MIL-C-26482G
AMENDMENT 6
3 May 2000
SUPERSEDING
AMENDMENT 5
3 January 1991

MILITARY SPECIFICATION

CONNECTORS, ELECTRICAL, (CIRCULAR, MINIATURE,
QUICK DISCONNECT, ENVIRONMENT RESISTING),
RECEPTACLES AND PLUGS, GENERAL SPECIFICATION FOR

This amendment forms a part of MIL-C-26482G, dated 5 September 1975, and is approved for use by all Departments and Agencies of the Department of Defense.

FIGURE 5C. Areas of applications of localized finish.”

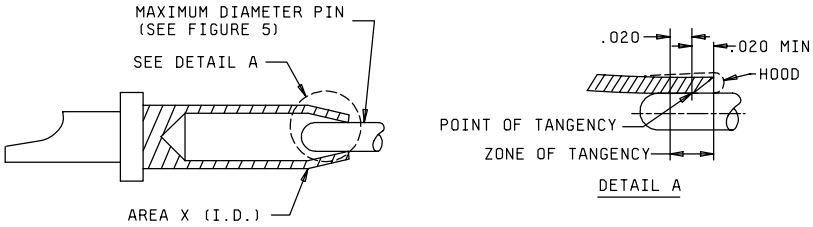
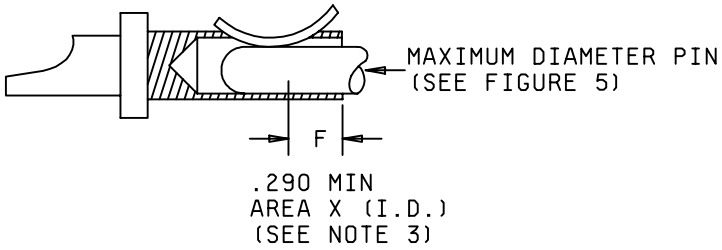
FIGURE 5C: Adding new figure on areas of applications of localized finish.
“

5C.1 Socket contact with integral pressure member (hood removed).

5C.2 Socket contact with separate pressure member as primary current carrying interface.

5C.3 Socket contact with separate pressure members.

5C.4 Pin contacts.

NOTES:
1. Dimensions are in inches.
2. Metric equivalents are given for general information only.
3. F equals length of maximum electrical contact (wiping) area plus .020 (0.51 mm) minimum. Maximum wipe shall be equal to maximum E of mating pin engagement minus the spherical radius.

FIGURE 14. Plating thickness measurement – overall finish (series I, solder).

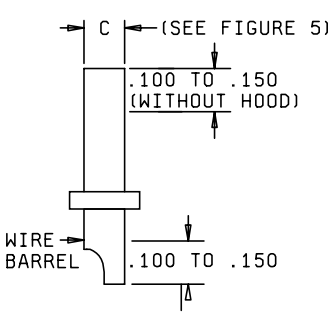
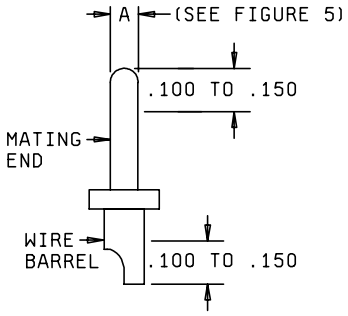
"4.6.51.1 Overall finish (see 3.3.5.1.1). Finish thickness shall be measured in accordance with MIL-G-45204. Measurements shall be made on the external surfaces of the contact body at the locations shown of figure 14.

Add new figures 14 and 15:

14A. Socket contacts.

14B. Pin contacts.

FIGURE 15. Plating thickness measurement - localized finish (series I, solder).”

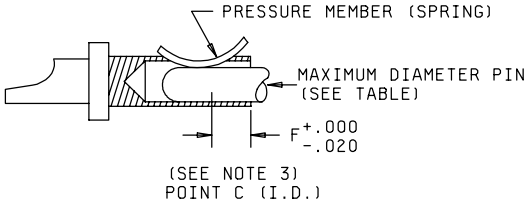
"4.6.51.2 Localized finish (see 3.3.5.1.2). Finish thickness shall be measured in accordance with MIL-G-45204. Measurements shall be made at point A or D of figure 15, as applicable.

15A. Socket contacts with integral pressure member.

15C. Socket contact with separate pressure member as primary current carrying interface.

15B. Socket contact with separate pressure members.

15D. Pin contacts.

NOTES:
1. Dimensions are in inches.
2. Metric equivalents are given for general information only.
3. F = .290, E = .290; F equals length of maximum electrical contact (wiping) area plus .020 (0.51 mm) minimum. Maximum wipe shall be equal to maximum E of mating pin engagement minus the spherical radius.
